Project	IEEE 802.16 Broadband Wireless Access Working Group < http://ieee802.org/16 >	
Title	On the issue of frame alignment and gaps	
Date Submitted	2007-11-1	
Source(s)	Dorin Viorel Fujitsu Microelectronics Canada Inc.	Voice: +1 403 207 6311 dviorel@fmci.fujitsu.com
	Michiharu Nakamura Fujitsu Laboratories Ltd	Voice: +81 468 39 5371 michi@labs.fujitsu.com
	Chenxi Zhu Fujitsu Laboratories of America Inc	Voice: +1 301 486 0671 chenxi.zhu@us.fujitsu.com
	Erik Colban Nextwave Broadband Inc	Voice: +1 858 480 3240 ecolban@nextwave.com
	Mary Chion ZTE USA	mchion@zteusa.com
Re:	In response to the LB#28 reply comments	
Abstract	This document provides proposed text for IEEE P802.16j on frame structure requirements and the definition of RSTTG and RSRTG	
Purpose	Discussion and adoption in the P802.16j draft	
Notice	<i>This document does not represent the agreed views of the IEEE 802.16 Working Group or any of its subgroups. It represents only the views of the participants listed in the "Source(s)" field above. It is offered as a basis for discussion. It is not binding on the contributor(s), who reserve(s) the right to add, amend or withdraw material contained herein.</i>

On the issue of fra

Figure 1 Frame structure (for informaion)

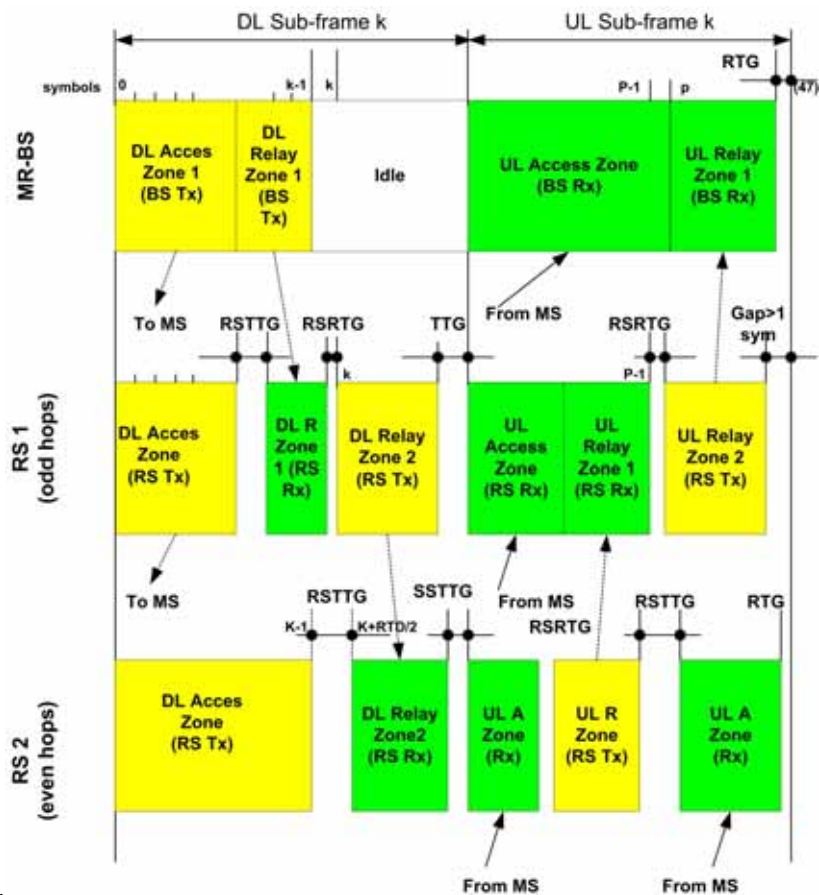
Figure 1 depicts MR-BS and RS frame structure with highlights of various gaps for information.
